Deck Repair

CODE COMPLIANCE: 2021 INTERNATIONAL EXIST BLDG CODE 2923 S. MERIDIAN ST (BLDG E) SITE ADDRESS: 0419032096

(Construction Plans, Sheet A1.1)

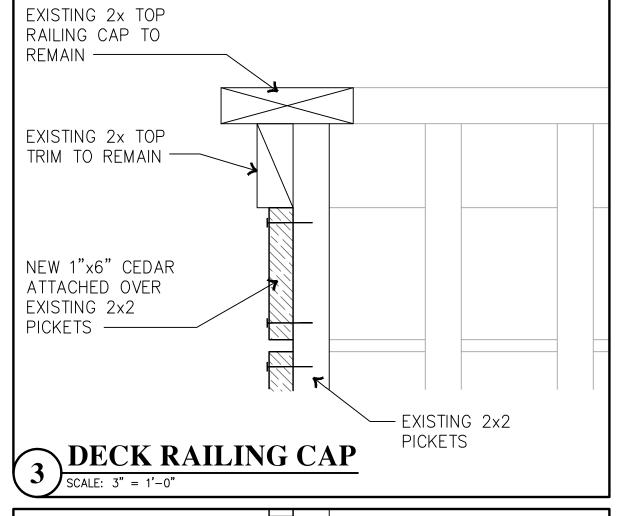
Determine the minimum required specifications for deck beams, posts, post bases, post caps and footings if replacements are necessary. Given the work already completed and the stop-work order in place, establish a clear benchmark to assess the completed work and provide clarity for future construction and inspection, minimizing any potential ambiguities.

(Construction Plans, Sheet A1.1)

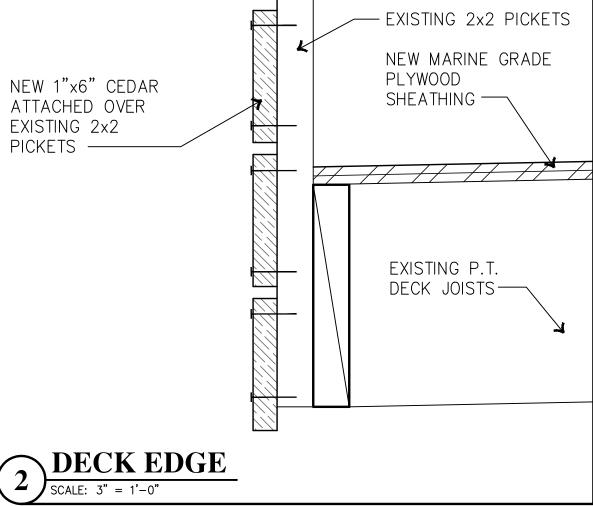
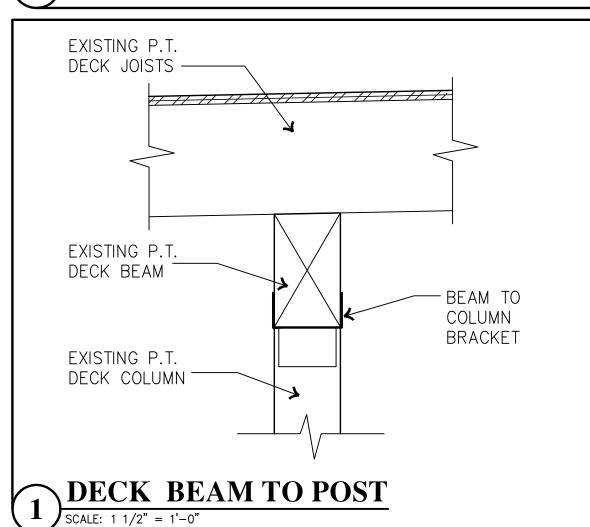
Deck joists appear to be sloped to drain off of the cantilevered side of each deck based upon details 1 and 2. Detail 2 shows the installation of the 1x6 cedar board over the existing 2x2 balusters. detail or notate how the 1x6 cedar will be installed to prevent drainage and water accumulation on the deck surface.

(Construction Plans, Sheet A1.1)

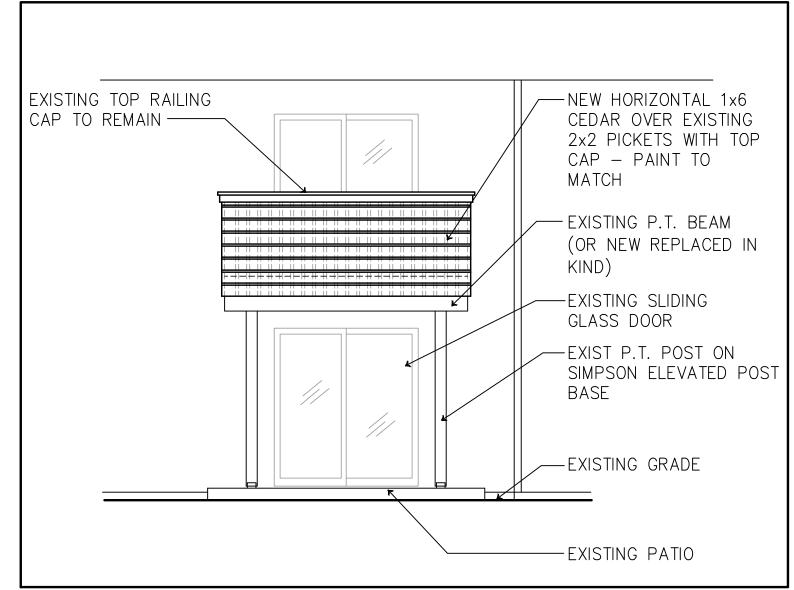
Add a notation on either Sheet A1.0 or A1.1 that contractor shall verify the integrity of balusters prior to the installation of the 1x6 cedar. Establish the parameters of the balusters replacement to include type, grade and nailing pattern.
